Well Name: BIG BUCKS FED COM	Well Location: T21S / R32E / SEC 1 / SESE / 32.5010392 / -103.6213522	County or Parish/State: LEA / NM
Well Number: 501H	Type of Well: OIL WELL	Allottee or Tribe Name:
Lease Number: NMNM092187, NMNM92187	Unit or CA Name:	Unit or CA Number:
US Well Number: 3002547064	Well Status: Approved Application for Permit to Drill	Operator: ASCENT ENERGY LLC

Notice of Intent

Procedure Description: Ascent Energy respectfully requests approval to revise the proposed BOP from a 5M BOP to a 2M BOP for the Big Bucks Fed Com 501H from beneath the base of the 20" surface shoe to setting the 1st Intermediate casing string only (13 3/8"). This revision is requested to accommodate the increase in the previously mentioned 1st Intermediate casing diameter of that string. Please see attached document for BOP schematic and sundry request specifics.

PECOS DISTRICT DRILLING CONDITIONS OF APPROVAL

2M ANNULAR BOPE & DIAGRAM

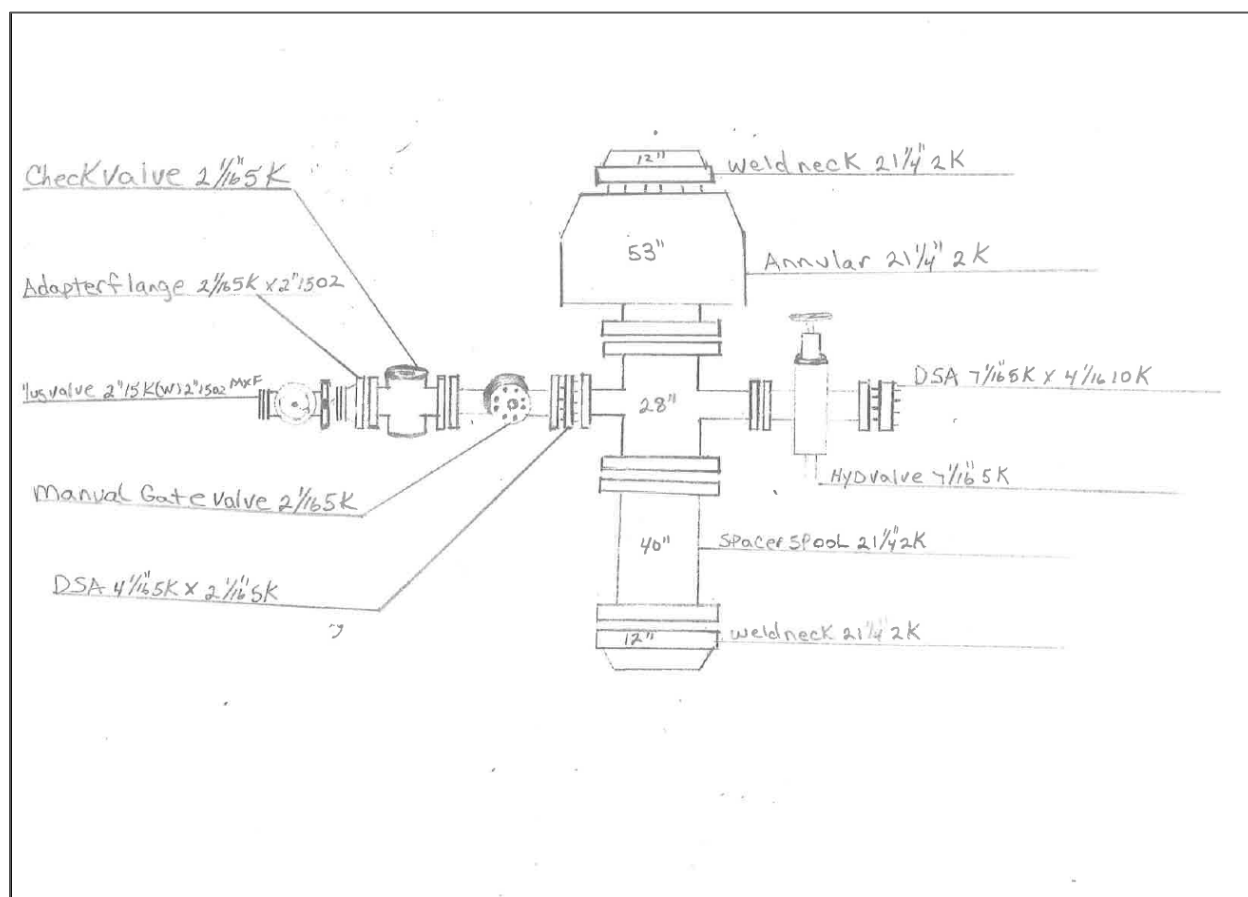
Ascent Energy respectfully requests approval to revise the proposed BOP for the Big Bucks Fed Com 501H from beneath the base of the 20" surface shoe to setting the 1st Intermediate casing string only (13 3/8"). This revision is requested to accommodate the increase in the previously mentioned 1st Intermediate casing diameter of that string.

From the Base of the 20" Surface pipe, the well will be equipped with a 2M Annular system. Before drilling out the 20" surface pipe, the 2M system will be tested to 250psi low and 1000psi high by an 3^d party service company. The 2M BOPE and related equipment will meet or exceed the requirements of a 2M psi system as set forth in On Shore Order No. 2 while drilling below the 20" surface shoe and to TD of Intermediate #1 (13-3/8" Casing). Once the Intermediate #1 13-3/8" Casing is cemented the 20" 2M BOPE and 21-1/4" wellhead will be removed and a 13-5/8" Multi-bowl wellhead and previously permitted 13-5/8" 5M BOPE will be installed. From the base of the Intermediate #1 13-3/8" casing string through running of the 5-1/2" production string the 5M BOPE will be equipped.

The previously permitted 5M choke will be utilized in conjunction with the 2M Annular System.

2. Operator has proposed a multi-bowl wellhead assembly. This assembly will only be tested when installed on the surface casing. Minimum working pressure of the blowout preventer (BOP) and related equipment (BOPE) required for drilling below the surface casing shoe shall be **2000 (2M) psi**.

3. Operator has proposed a multi-bowl wellhead assembly. This assembly will only be tested when installed on the surface casing. Minimum working pressure of the blowout preventer (BOP) and related equipment (BOPE) required for drilling below the intermediate 1 and 2 casing shoe shall be **5000 (5M) psi**.
